Access Compliance Report

Public Rights-of-Way

(Curb Ramps)

Intersection ID: 21505	Main Street: COTILLION_AV	Cross Street: REBEL_DR	Location:	S
ADA ID: BD220FA00E3B	Ramp Type: Directional1	Initial Pass/Fail: Fail	Overall Compliance: No	Severity Score: 10
Codes/Mitigation Info/Possible Solution		Field Measurements/Component Compliance

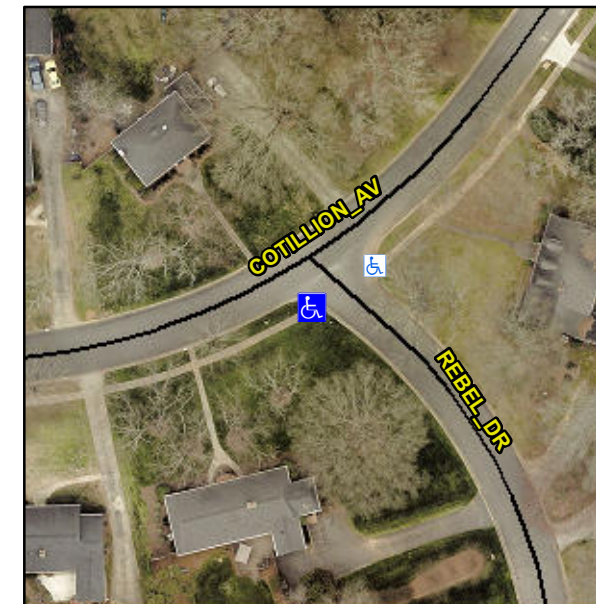
R304.5.1, R304.5.3

Compliance	Description	Data	Compliance	Description	Data
N/A	Ramp Length (in)	29.0	N/A	Grade Break?	N/A
No	Ramp Width (in)	47.5	N/A	Grade Break Slope (%)	0.0
Yes	Ramp Slope (%)	3.8	N/A	Grade Break XSlope (%)	0.0
No	Ramp XSlope (%)	4.0			
N/A	Flare Type LT	N/A	N/A	Flare Type RT	N/A
N/A	Flare Slope LT (%)	N/A	N/A	Flare Slope RT (%)	0.0
N/A	Flare Traversable LT?	N/A	N/A	Flare Traversable RT?	N/A
N/A	Landing Length (in)	0.0	N/A	DWS Provided?	N/A
N/A	Landing Width (in)	0.0	N/A	DWS Contrast?	N/A
N/A	Landing Slope (%)	0.0	N/A	DWS Length (in)	N/A
N/A	Landing X Slope (%)	0.0	N/A	DWS Full Width?	N/A
N/A	Landing Curb? (Y/N)	N/A	N/A	DWS Offset LT (in)	N/A
N/A	Shared Landing?	N/A	N/A	DWS Offset RT (in)	N/A
N/A	Gutter Ponding?	0.0	N/A	Gutter Slope (%)	N/A
N/A	Gutter Lip Ht (in)	0.0	N/A	Gutter X Slope (%)	N/A
N/A	Painted X Walk1?	No		Road Slope (%)	6.7
	X Walk 1 Direction	To NE		Road X Slope (%)	0.8
	X Walk 1 Width (in)	N/A		Clear Space?	N/A

X Walk 1 Slope (%)	6.7	N/A	Clear Space to XWalk (in)	N/A
	X Walk 1 X Slope (%)	0.8	N/A	Storm Grate/Utility Hazard?	N/A
N/A	Ramp inside XWalk1?	N/A		Storm Grate/Utility Type	
N/A	Any Obstructions?	N/A			N/A
	Obstruction Type		Yes	Surface Condition? (G/P)	Good
			N/A	Curb Slope (%)	14.8

Remove & Replace Entire Ramp.
